STATE OF INDIANA
INDIANA UTILITY REGULATORY COMMISSION

INDIANA OFFICE OF UTILITY CONSUMER COUNSELOR
PUBLIC'S EXHIBIT NO. 3
TESTIMONY OF OUCC WITNESS
JOHN W. HANKS

TESTIMONY OF OUCC WITNESS JOHN W. HANKS
CAUSE NO. 46193
DUKE ENERGY INDIANA, LLC

INDIANA OFFICE OF UTILITY CONSUMER COUNSELOR COMMENTS ON DUKE ENERGY INDIANA'S 2024 IRP FEBRUARY 13, 2024

17 **Figure 4-7: Present Value Revenue Requirement ("PVRR") by Generation Strategy**
18 **Including "No 111" Strategy Variation**

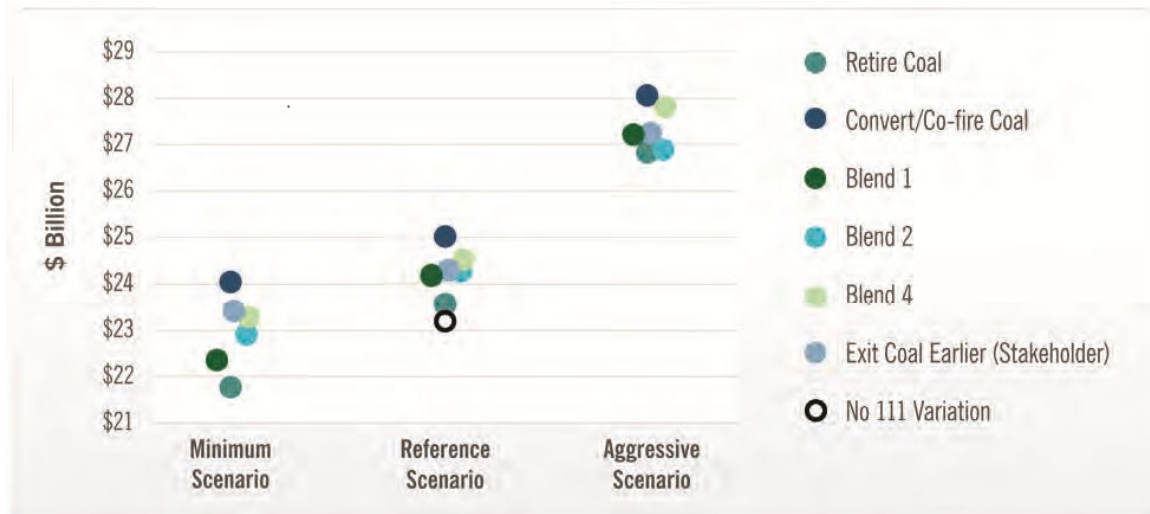
6 A: The current regulatory environment is more consistent with the "Minimum Policy
7 & Lagging Innovation" scenario, which relaxes EPA Rule 111 requirements. This
8 is significant when developing a resource plan or short-term action plan based on
9 the results of Duke's 2024 IRP because, as the Company states, "[present value
10 revenue requirement] results diverge most in the Minimum Scenario, which
11 contemplates relaxed regulatory restrictions. With more flexibility, the total cost of
12 each generation strategy is lower in the Minimum Scenario than in the Reference
13 Scenario."¹⁷ If the Minimum Policy scenario better reflects the current regulatory
14 climate, then it becomes more problematic that Duke did not justify its selection of
15 Blend 2.

16 This greater variability of PVRR results is shown in the following figure:¹⁸

It is notable that in the Minimum Scenario, the difference between the PVRRs of Blend 1 and Blend 2 is even greater than in the Reference Scenario. Blend 1 has an associated PVRR of \$22.3 Billion which is approximately \$600 Million less expensive than Blend 2, which has a PVRR of \$22.9 Billion. In brief, Blend 1, which includes the Cayuga units converting to natural gas, will be less costly to ratepayers in both the Reference Scenario and, especially, the Minimum Policy scenario. Duke has not established that its preferred portfolio, which includes retiring the Cayuga coal units to be replaced by new gas CCs, is in the best financial interest of its customers, particularly given the regulatory changes not adequately reflected in its preferred portfolio.

3 **Figure 5: PVRR Comparison of Blend 4 to Convert/Co-fire Coal**

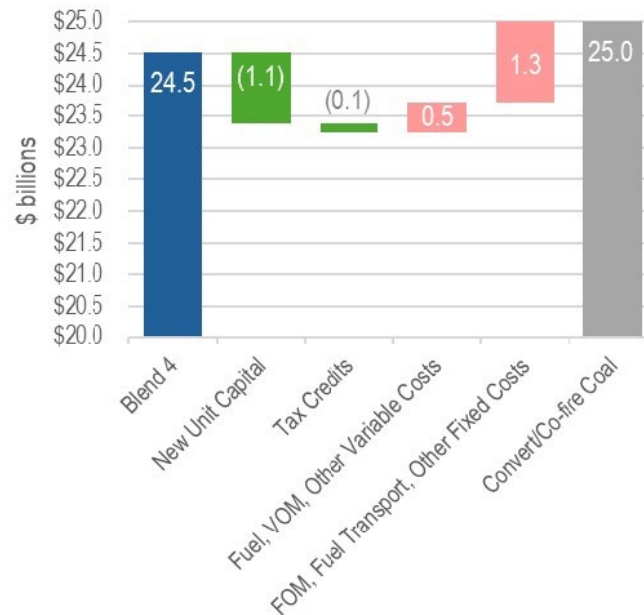
4
 5 Notice that Blend 4 has \$1.1 Billion greater capital costs than the Convert/Co-fire
 6 coal strategy. As I discuss later, the costs of a CC included in the IRP for the base
 7 scenario are significantly lower than the costs proposed for the Cayuga CC Project
 8 in this case. Therefore, Gagnon’s capital cost comparison understates the costs of
 9 new CCs and makes the retirement of the Cayuga coal units look more attractive. I

1 also note that Blend 1 includes the conversion of the Cayuga units to natural gas,
2 and it has a lower PVRR than the preferred portfolio.
